Subject: Nuclear Safety Related Qualification of the Tricon TMR Programmable Logic Controller (PLC) – Update to Qualification Summary Report Submittal and “Application for Withholding Proprietary Information from Public Disclosure” (TAC NO. ME2435)

Supplementary Information – Selected Topics

Responses to technical issues 08/03/2010

Clarification of Safety-Related Primary RXM to Non-Safety-Related Remote RXM Chassis

Figure 1 - Safety-Related System with Non-Safety Remote Location (Figure 3 in NTX-SER-09-10)

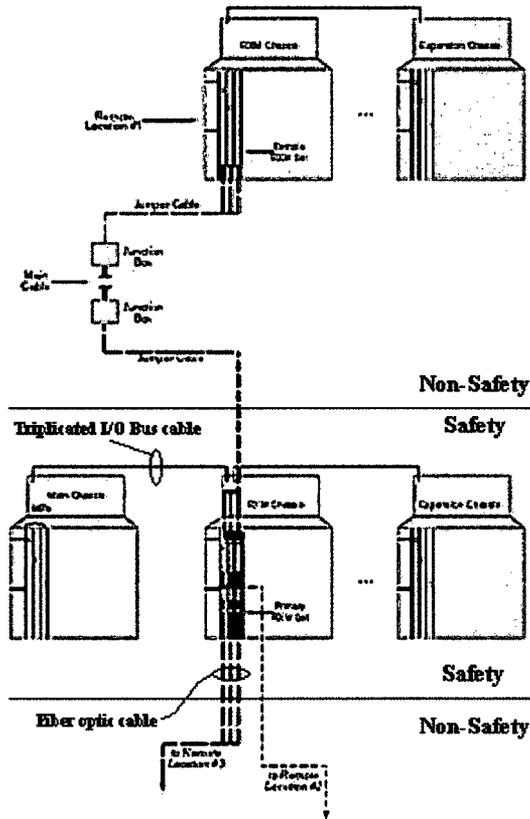
The NRC has requested additional information on conformance to staff guidance on safety-to-nonsafety communications of certain configurations of the V10 Tricon.

Invensys document NTX-SER-09-10, "Tricon Applications in Nuclear Reactor Protection Systems – Compliance with NRC Interim Guidance ISG-2 & ISG-4," describes the V10 Tricon conformance to Interim Staff Guidance on communications between safety and non-safety systems contained in DI&C-ISG-04 (ISG-04). The staff has identified some concerns with NTX-SER-9-10 Section 2, *V10 Tricon Chassis Configurations*, and 3.2, *V10 Tricon Communications – Safety-to-Nonsafety Communications*, regarding proposed safety-to-nonsafety V10 Tricon architectures. Figure 1, below, taken from NTX-SER-09-10, shows a safety-related Main Chassis connected to a safety-related Primary RXM Chassis, which is, in turn, connected to a non-safety Remote RXM Chassis. The staff has requested clarification on how the configuration depicted in the figure meets ISG-04. Specifically, the staff has asked for clarification on the communications isolation, and impact on the safety function upon worst-case failure of the non-safety RXM chassis and/or input/output (IO) module in the non-safety RXM chassis.

The Invensys response addresses the staff's concerns by highlighting the conclusions from the V9 Tricon safety evaluation that are relevant to the staff's "delta review" of the V10 Tricon, and by discussing compliance of the V10 Tricon to the applicable regulatory requirements. The discussion below builds upon technical information in Section 2.1 of Invensys document NTX-SER-09-10. Additional technical

The Invensys response will explain how the proposed architecture in Figure 1 meets the independence requirements in IEEE Standard 603-1991 (i.e., Physical, Electrical, and Communications Independence), as well as describe software barriers inherent in the V10 Tricon RXM technology.

In Figure 1 a safety-related Main, RXM, and Expansion Chassis are shown. Connected to the safety-related RXM Chassis via fiber-optic cables are a non-safety-related RXM and Expansion Chassis (connected via a 9000-series copper cable). In accordance with IEEE Standard 603-1991 and guidance in Chapter 7 of the SRP, the requirements for physical independence are satisfied by physical separation of safety- and nonsafety-related equipment in their respective chassis, as well as by distance. By definition, the RXM Chassis is utilized when the remote I/O is separated from the Main Chassis at a distance exceeding the capability of the 9000-series copper cable (greater than 100 feet). Therefore, the non-safety remote RXM Chassis would typically be located at a distance that would ensure compliance with the physical separation requirements of IEEE Standard 603. The Primary RXM would always be safety-related to maintain traceability to the V10 Tricon nuclear qualification, thus the Primary RXM and Main Chassis would not be subject to the separation criteria.
